**PITTMAN TERRACE WATER QUALITY IMPROVEMENT PROJECT  
GLENBROOK, NEVADA**

## ADDENDUM NO. 1, Page 2 of 3

FRIEDHOFF DRIVE DRAINAGE  
PITTMAN TERRACE WATER QUALITY  
IMPROVEMENT PROJECT

2  
D-2

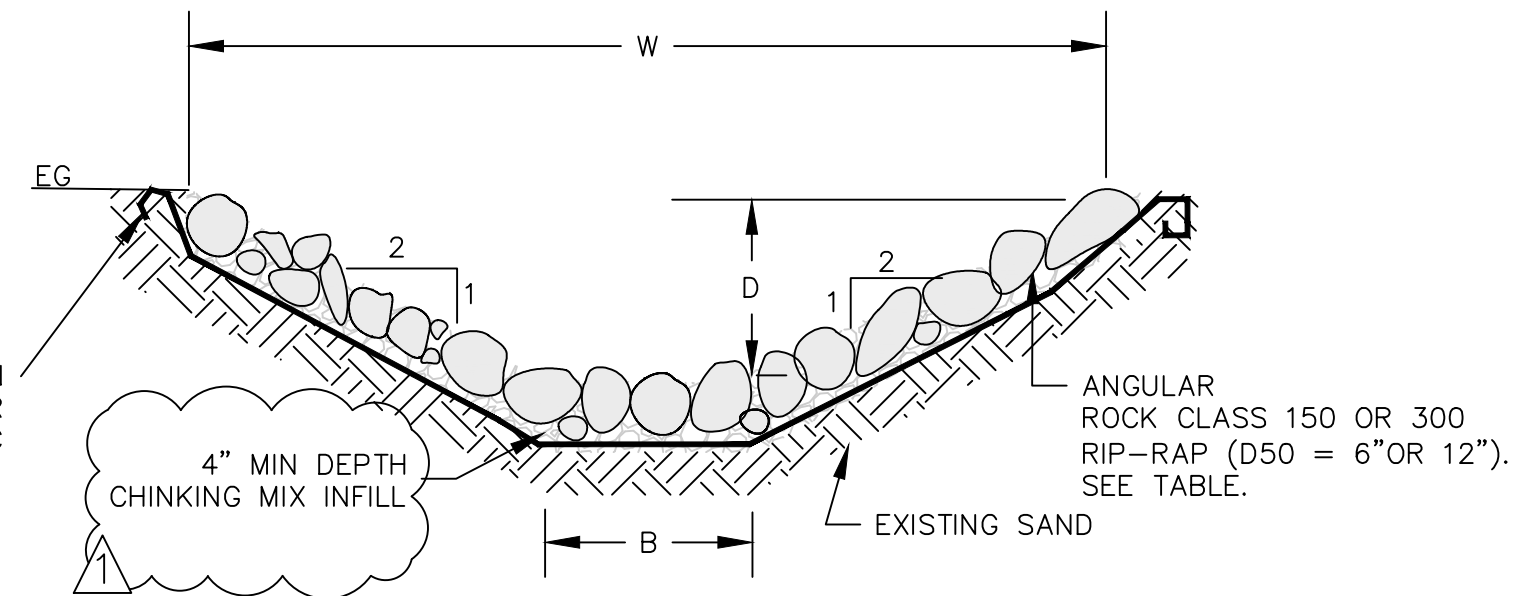
7. Sheet D-2: Block Channel detail 2/D-2 replaced the sand layer with filter fabric, which is called out as North America Green P300, Propex Geosynthetics Landlok TRM 450, or approved equal. Clarification has been added to show the concrete edge at a 12" depth. Note 1 has added clarification to the revegetation that blocks are to be filled 70% with topsoil.

- BLOCK CHANNEL NOTES:**
- SEE REVEGETATION PLAN AND SPECIAL PROVISIONS FOR REVEGETATION DETAILS. BLOCKS TO BE FILLED 70% WITH TOPSOIL AND SEEDED PER SPECIAL PROVISIONS.
  - SAWCUT PAVEMENT ON FRIEDHOFF DRIVE TO CREATE SMOOTH TRANSITION BETWEEN ROAD AND CHANNEL. SEE STREET CUT REPAIR DETAIL 1/D-4.
  - CONCRETE EDGE TO BE INSTALLED ON UPSTREAM AND DOWNSTREAM EDGE OF BLOCK CHANNEL AS WELL AS ALONG THE SIDES OF THE CHANNEL AS SHOWN..

3  
D-2

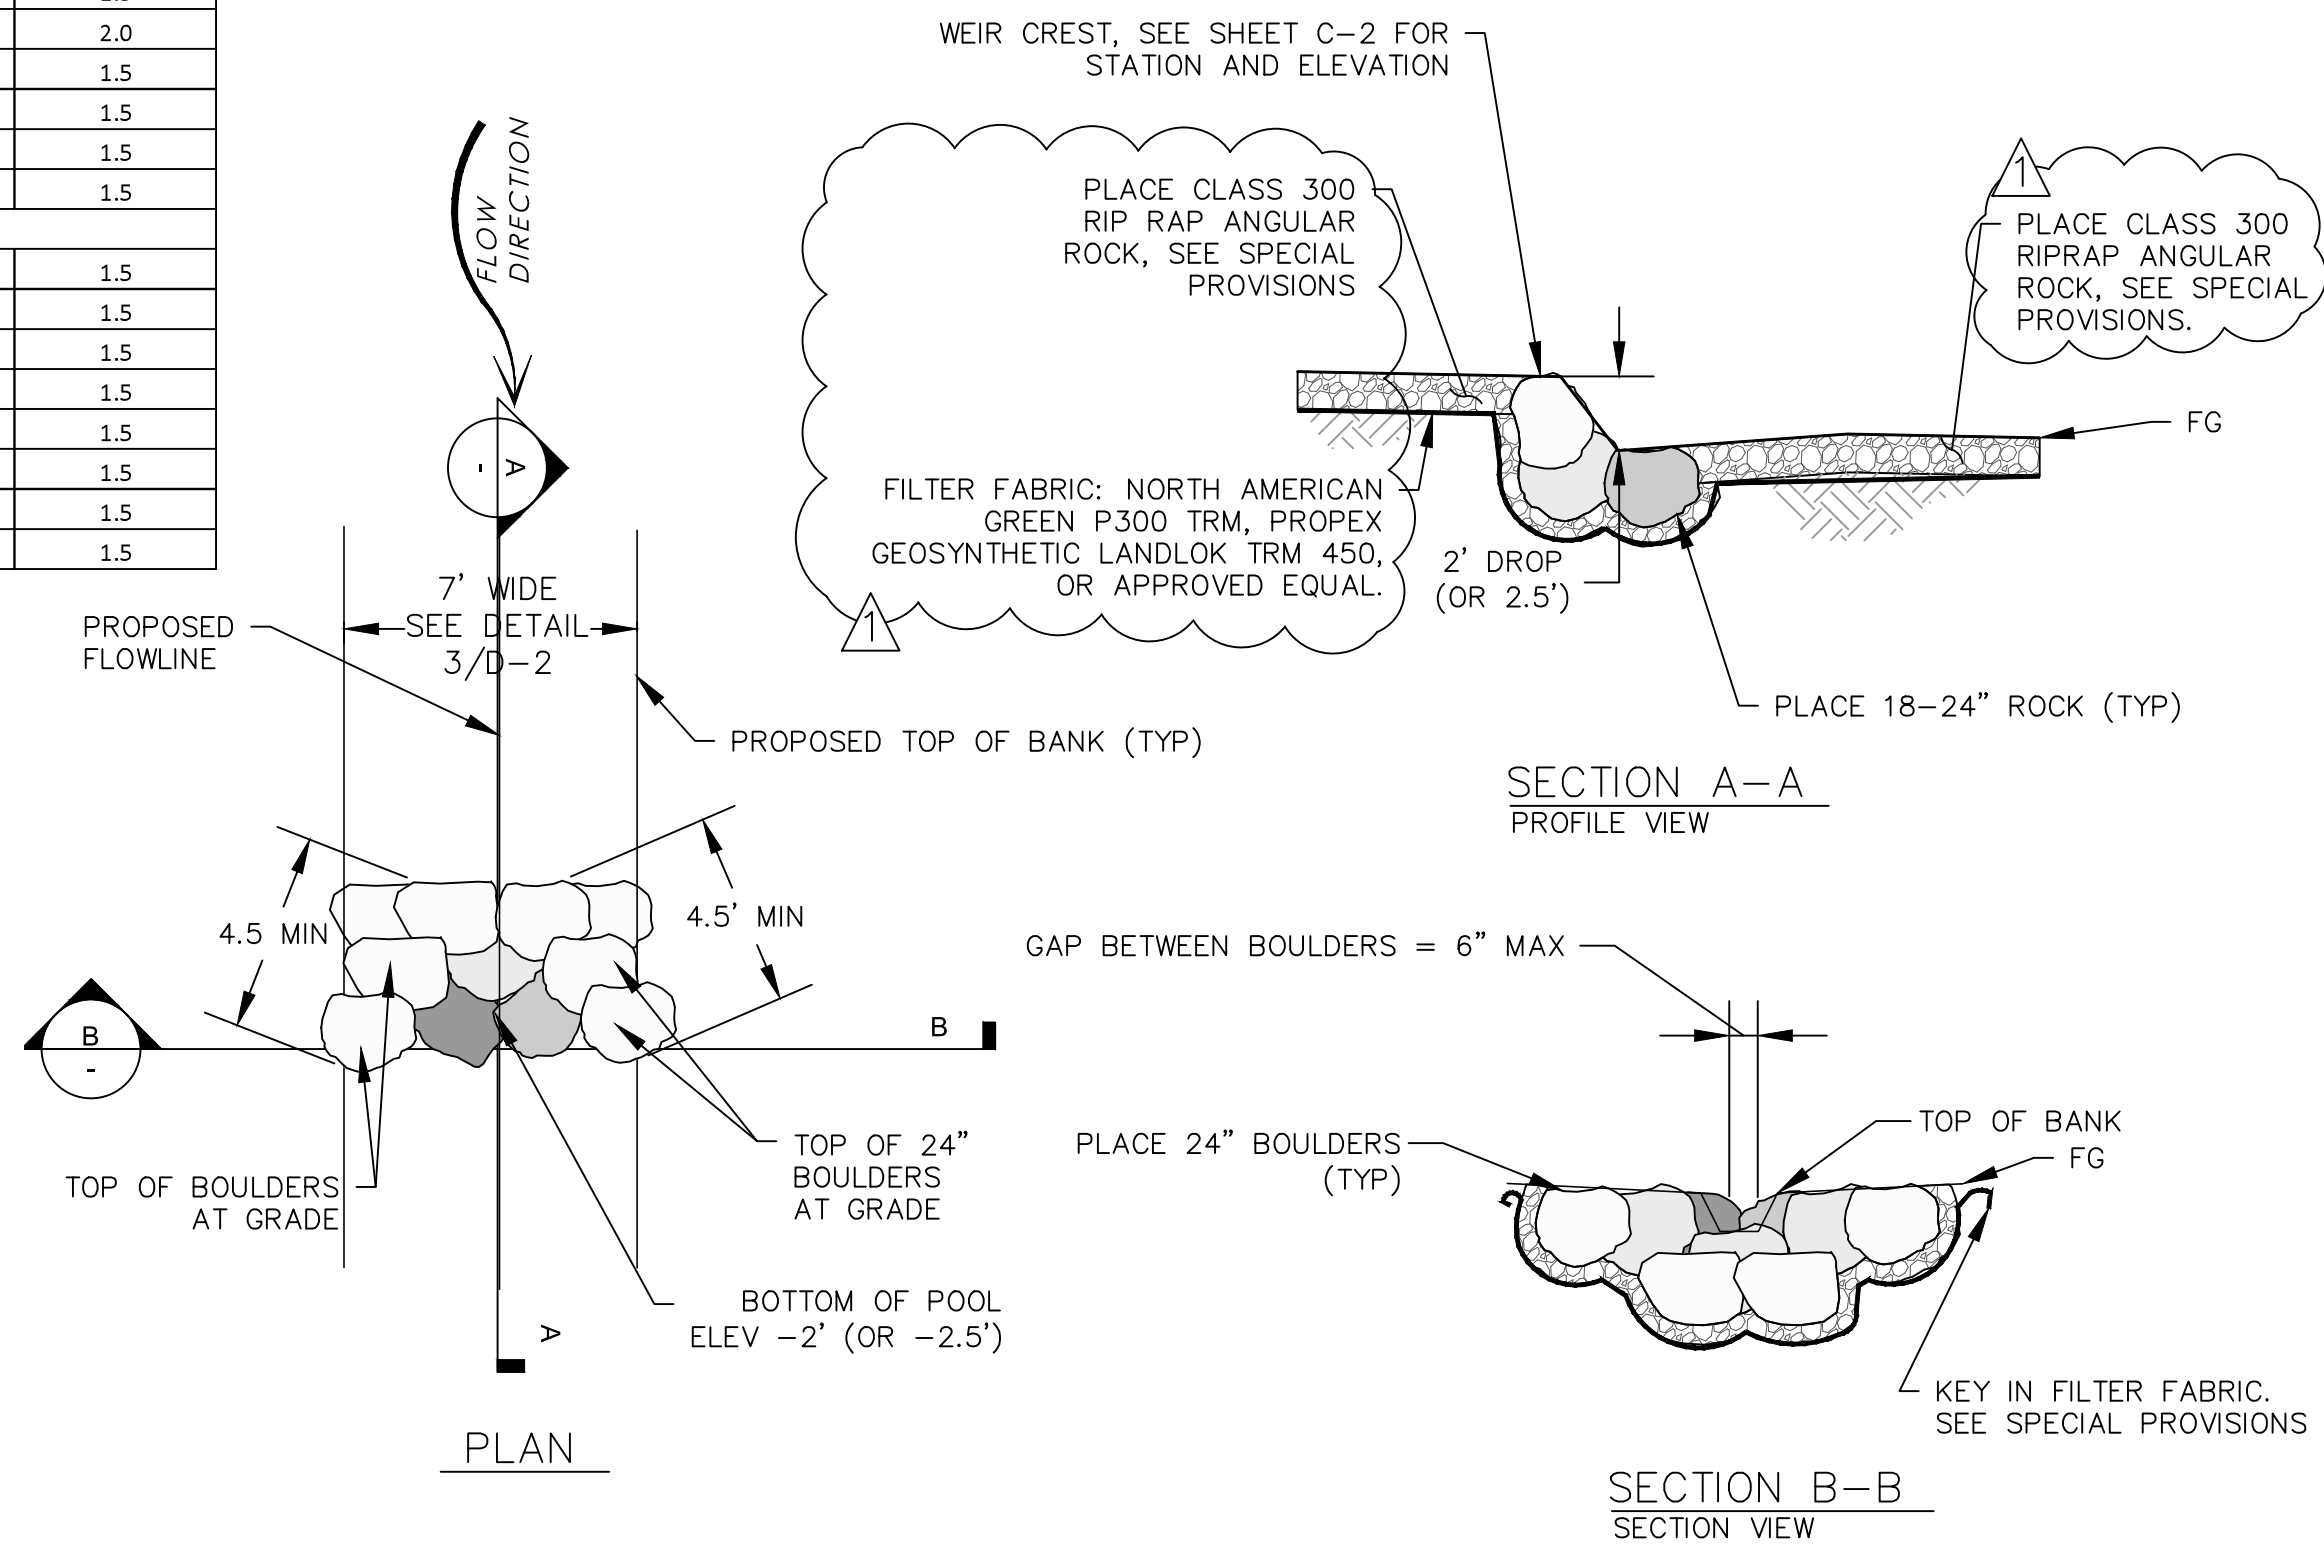
8. Sheet D-2: Rock Lined Channel detail 3/D-2 has added rip rap depths to the rock lined channel table and revised the notes to specify the type of filter fabric to place under the channel as North America Green

P300, Propex Geosynthetics Landlok TRM 450, or approved equal. The infill type has been clarified as chinking mix.

ROCK LINED CHANNEL TABLE						
ALIGNMENT NAME	BGN STATION [FT]	END STATION [FT]	W [FT]	B [FT]	D[FT]	RIP RAP CLASS
FRIEDHOFF DR.	1+67.4	2+19.5	3.5	0.5	0.75	CLASS 150
DOUGLAS BLVD.	2+67.9	3+85.2	7.0	1	1.5	CLASS 300
DOUGLAS BLVD.	3+85.2	3+90.6	TRANSITION			CLASS 300
DOUGLAS BLVD.	3+90.6	4+20.3	17.0	5.0	2.0	CLASS 300

- RLC NOTES:**
- REVEGETATION IN ROCK LINED CHANNEL BY OTHERS.
  - SAWCUT PAVEMENT ON FRIEDHOFF DRIVE TO CREATE SMOOTH TRANSITION BETWEEN ROAD AND CHANNEL. SEE STREET CUT REPAIR DETAIL 1/D-4.
  - FILTER FABRIC SHALL BE NORTH AMERICAN GREEN P300 TRM, PROPEX GEOSYNTHETIC LANDLOK TRM 450, OR APPROVED EQUAL.

4  
D-2

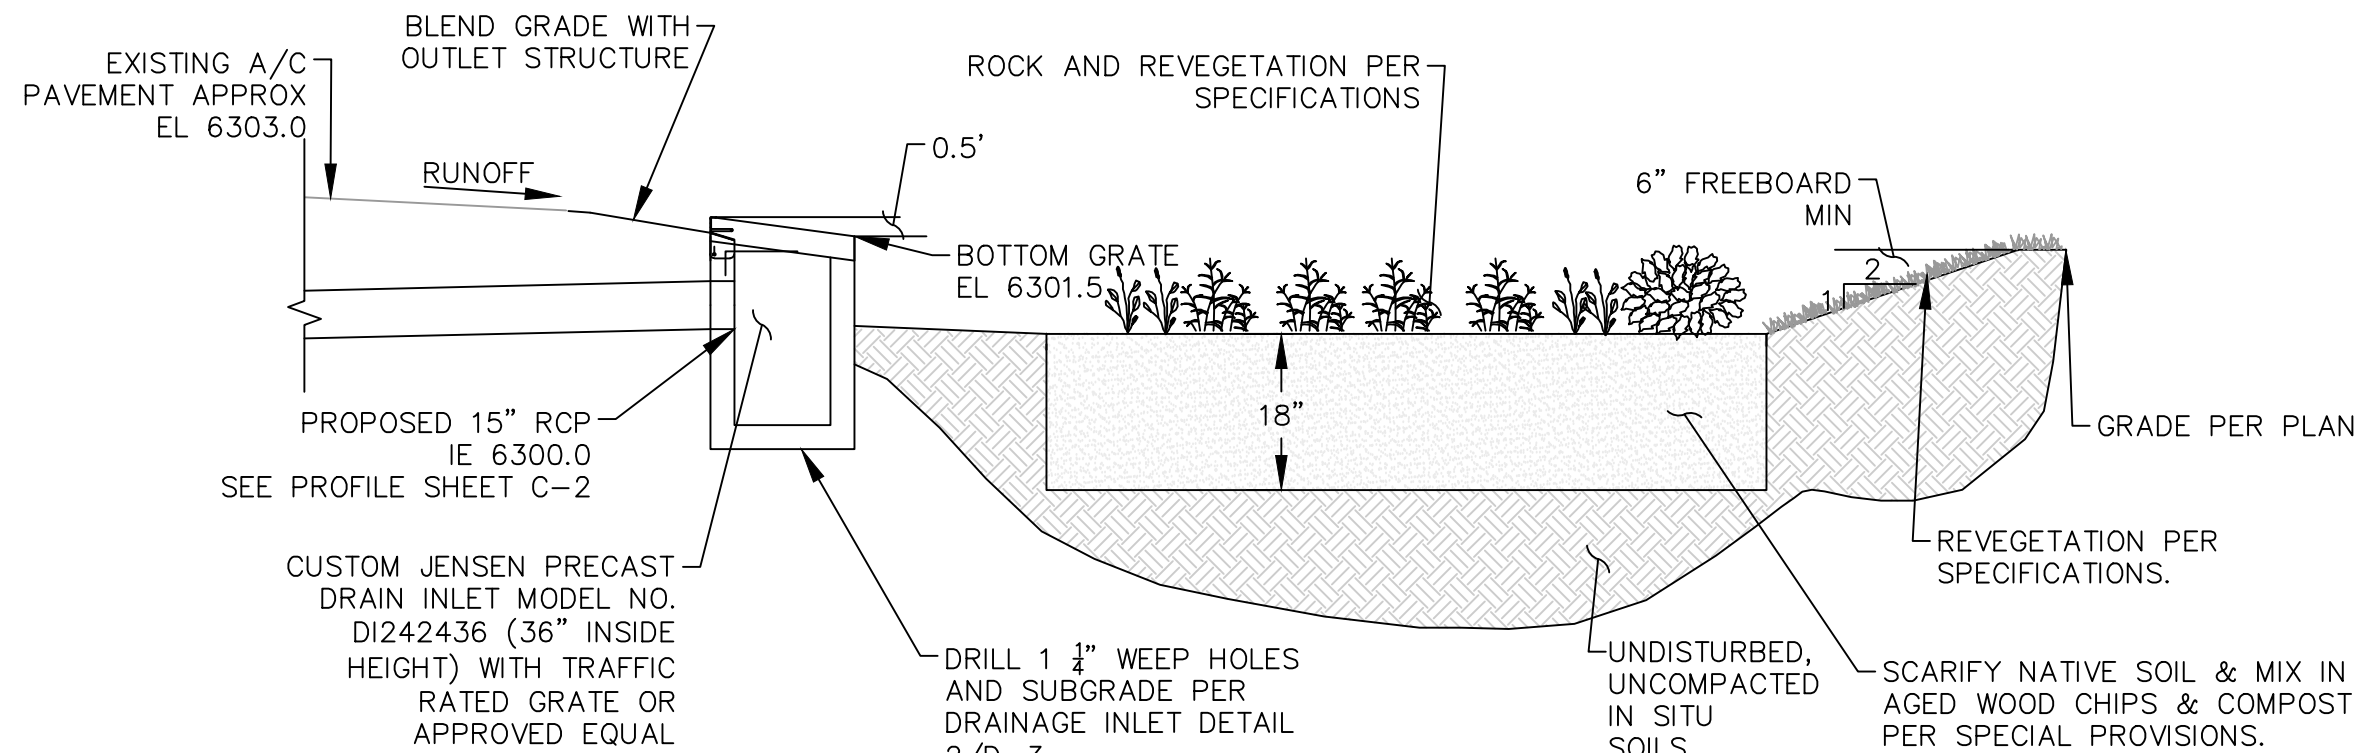
9. Sheet D-2: Rock Drop Structure detail 4/D-2 has added the type of filter fabric to be used as North America Green P300, Propex Geosynthetics Landlok TRM 450, or approved equal. The class of rip rap used shall be Class 300.

1  
D-3

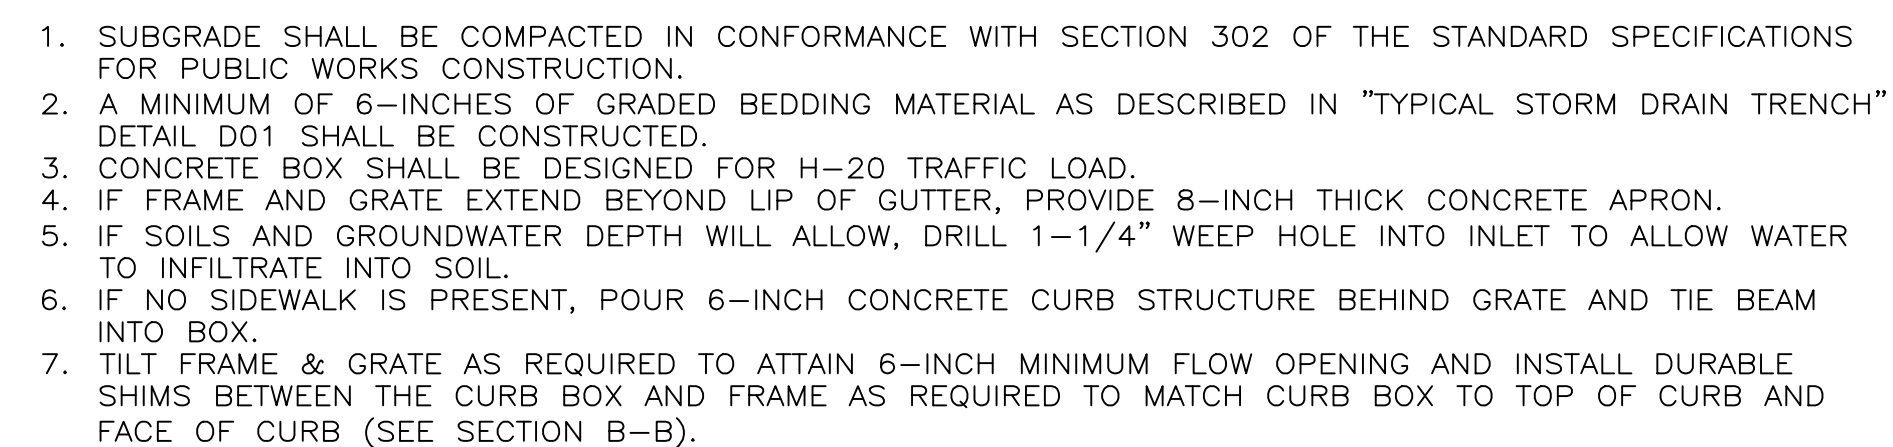
10. Sheet D-3: Retrofit NDOT Infiltration System detail 1/D-3 has been changed to eliminate the modification to the existing CMP and the added drain rock in between the existing DI and sediment cans. The proposed CMP shall be connected with a field joint, continuous weld. Filter fabric was added to wrap the proposed drain rock. The filter fabric shall be 4-ounce, non-woven geotextile.

11. Sheet D-3: Details 2/D-3 and 3/D-3 have been modified to eliminate discrepancies. The Jensen Precast drainage inlet shall be model no, DI243648-4R or approved equal. Perforated HDPE shall be 18" in diameter. Weep holes shall be drilled, one on each side of the drainage inlet. The subgrade shall be 6" AB compacted to 95% relative compaction and extend a minimum of 6" outside of the drainage inlet footprint.

12. Sheet D-3: Detail 4/D-3 has been modified to add 4-ounce, non-woven geotextile fabric as a barrier between the block channel base and the drain rock. Weep holes shall be drilled, one on each side of the drainage inlet. The subgrade shall be 6" AB compacted to 95% relative compaction and extend a minimum of 6" outside of the drainage inlet footprint.
